188 Beaumont Street Fast-track

Auckland Council Specialist Memo

Auckland Transport

2.0 Technical Specialist Memo – Vaishali Sankar (Development Planning)

Figure 2: Morning Peak network effects
Reference: Integrated Transport Assessment prepared by Parlane & Associates

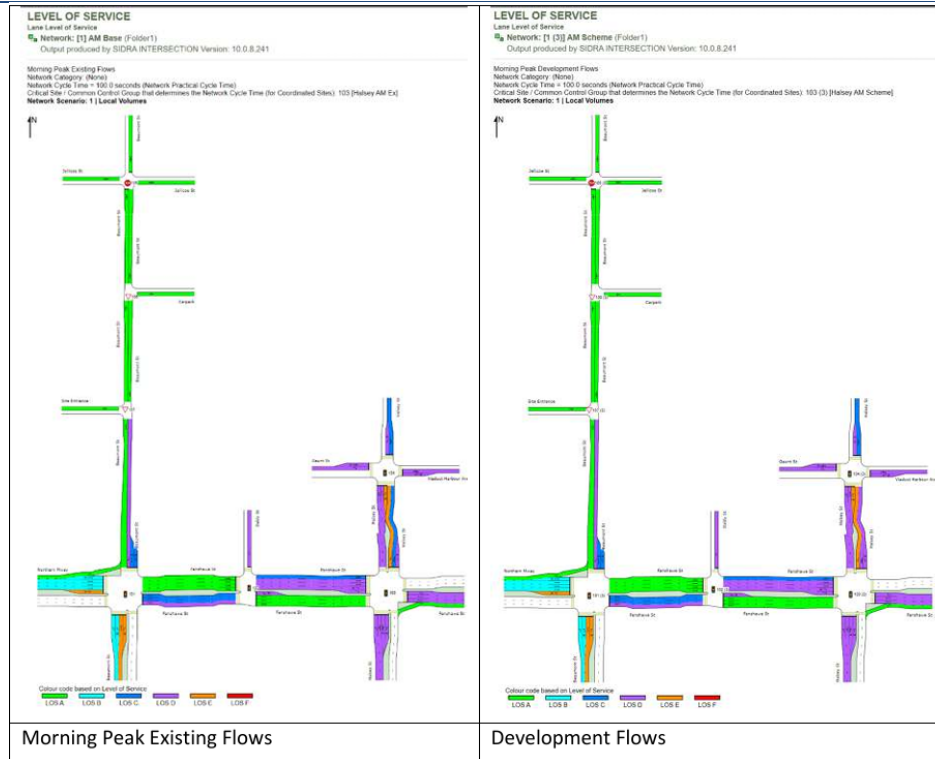
5.15 SIDRA modelling was undertaken to assess changes in Level of Service (LOS) at a network level. The results indicate an increase in delay on Halsey Street south of Viaduct Harbour Drive during the AM peak, and a change in LOS on Halsey Street north of Viaduct Harbour Drive during the PM peak compared to the baseline, as shown below.

5.16 This change is expected given the scale of the proposed development. However, the ITA does not include the detailed SIDRA modelling output required to verify the input data or assess changes in average delay, speed, queue length, and potential impacts on PT services.

5.17 It is recommended that the SIDRA network model report be provided to better understand the extent of changes in queue length and average delay.

Figure 4: Truck Tracking Rubbish Direct

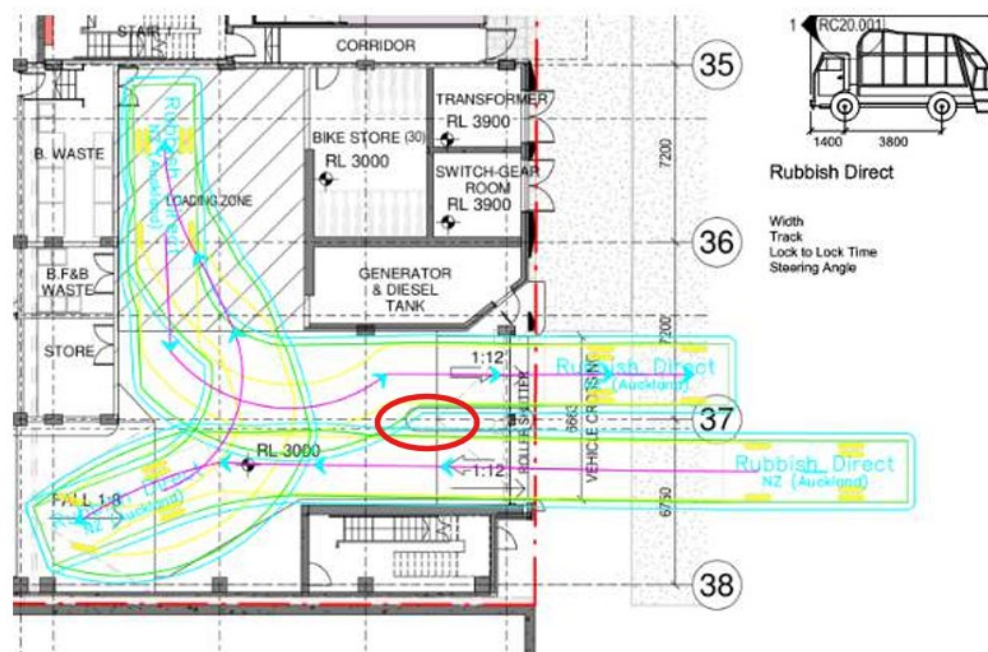
5.18 Figure 14 (Truck Tracking Rubbish Direct) in the ITA indicates that the truck slightly tracks over the proposed median separation at the access, as shown below. It is recommended that the applicant review the tracking curves and the location of the proposed median.
